CITY OF ALBUQUERQUE

PLANNING DEPARTMENT – Development Review Services

**RE: Northpoint Townhomes (B18D001C)
Supplemental Information (Report), Engineer's Stamp Date 8-24-16
Grading and Drainage Plan, Engineer's Stamp Date 8-24-16**

Supplemental Information

DATE: 7-8-16
CONFERENCE RECAP

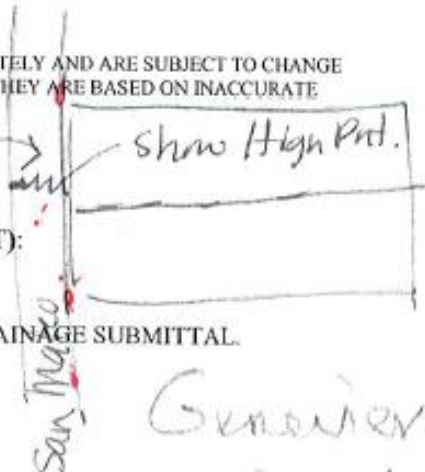
- ① Split Basin 2 so that half discharges to N. San Mateo (past hi. pt)
- ② Basin 5 will not require first flush + should be discharged as far downstream on San Mateo (S. of High Pnt) as ^{far} possible.
- ③ Existing discharge of 30.3 cfs is being reduced. (so 1 lane dry does not qualify)
- ④ Basin 2 may not be reqd to have first flush.
- ⑤ Adjust DMP Basin Map as such:
